TITLE: SMA50 (M) BNC50 (M) ST ADAPTOR

DWG NO. AD00003-7/3

REVISION 3

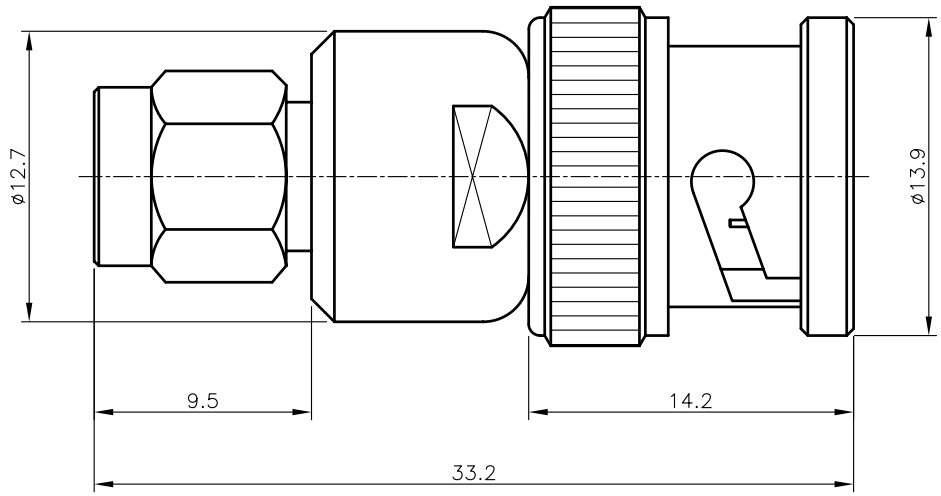
REV	DESCRIPTION	DRAWN	APPR	DATE
R	Initial Registration			2009.05.18.
1	신뢰성향상[설변No.200905-0018] (SMA부 BODY+TEF GAP발생-TEFLON 코드변경)	E.H.KIM	S.J.YOUN	2000.01.04.
2	[설변처리No.201303-0012] 신뢰성 향상 (낚시바늘 추가 및 내부 형상 변경)	E.H.KIM	I.C.KIM	2013.03.14.
3	[설변처리No.201811-0004] 절연체 가공 난해로 인해 분할 구조로 변경	I.C.KIM		2018.11.21.

NO.	DESCRIPTION	Q'TY	MATERIAL	PLATING	CODE
	12	SPRING RING	2	BeCu	Nickel Plate	DWA00069-5/1 (R6001)
	11	SPRING RING	1	SUS	부동태 처리	DSR00002-5/1 (R2001)
	10	WASHER	2	BsS	Nickel Plate	DWA00016-5/1 (Q6002)
	9	WASHER	1	BsS	Nickel Plate	DWA00015-5/1 (Q6001)
	8	BNC CAP	1	MBsBD	Nickel Plate	DCU00044-5/1 (K6001)
	7	COUPLING CAP	1	MBsBD	Gold Plate	DCU00005-5/1 (K2001)
3	6	INSULATOR	1	TEFLON	White	DIN01895-N/1
3 2 1	5	INSULATOR	1	TEFLON	White	DAI00020-N/2 ~~DAI00020-N/1 (EA008)~~
	4	GASKET	1	SILICONE	Red	DGK00012-N/1 (G6001)
	3	GASKET	1	SILICONE	Red	DGK00004-N/1 (G2001)
2	2	CONTACT	1	MBsBD	Gold Plate	DAC00032-5/2 ~~DAC00032-5/1 (EA008)~~
2	1	BODY	1	MBsBD	Nickel Plate	DAD00005-5/2 ~~DAD00005-5/1 (DA010)~~
